HALIFAX

Appeal HearingSite Plan Approval 23653

1109 Fall River Road, Fall River

North West Community Council, March 7

SITE PLAN

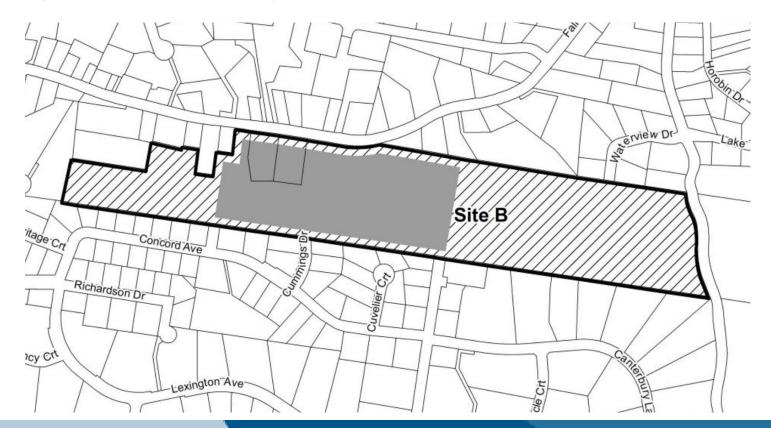
Crit	eria	Review Comment
1	Applications for Site Plan Approval shall be in the form specified in Appendix B.	The application submitted meets all submission requirements as outlined in Appendix B of the Planning Districts 14 and 17 Land Use By-Law.
2	All Applications for Site Plan Approvals shall be accompanied by a site plan drawn to scale and of sufficient detail to address all matters identified in this Section.	The site plan submitted is drawn to scale and includes sufficient detail to address all matters identified in this section.
3 (a)	All proposed and existing buildings shall be located centrally on the site, as generally shown on Schedule O as "General Area of Development";	The site plan shows all proposed and existing buildings to be located centrally on the site, as generally shown on Schedule O as "General Area of Development".

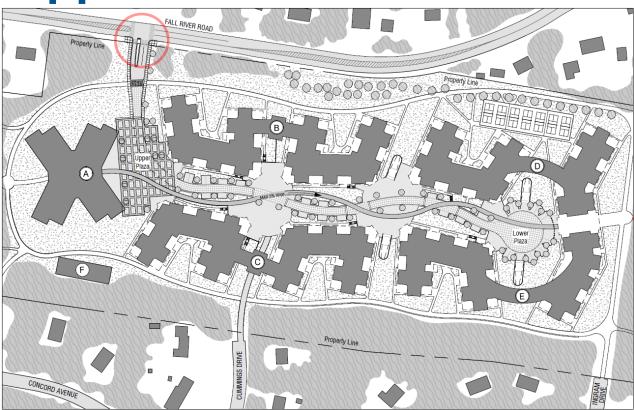
Crite	eria	Review Comment
3 (b)	All proposed parking and loading facilities shall be located: (i) in close proximity to the buildings, and (ii) centrally on the development site, as generally shown on Schedule O as "General Area of Development". (Parking may include underground parking).	The site plan shows all proposed parking and loading facilities to be located in close proximity to the buildings and within the "General Area of Development".
3 (c)	Driveway access shall be limited to one access to Fall River Road and any existing driveway access that the Development Officer determines is no longer necessary shall be removed;	The site plan shows one proposed driveway access to Fall River Road.

Crite	eria	Review Comment
3 (d)	An emergency secondary access shall be provided to Cummings Drive or Ingram Drive, as required;	The site plan shows the proposed emergency secondary access to Cummings Drive.
3 (e)	Landscaping, hedges, or fencing shall be used as buffering along the yard setbacks, parking areas, and along property lines;	The site plan shows proposed landscaping and utilizes existing vegetation along the yard setbacks, parking areas, and along property lines.
3 (f)	Within the non-disturbance area, (i) existing natural vegetation shall be retained, and (ii) activity shall be limited to walkways and trails not exceeding 3 metres in width, conservation uses, driveway crossings, and infrastructure for wastewater, stormwater, and water, and water control structures;	The site plan shows existing natural vegetation is to remain within the non-disturbance area, and activity is limited to walkways and trails, driveway crossings, and infrastructure for wastewater, stormwater and water, and water control structures.
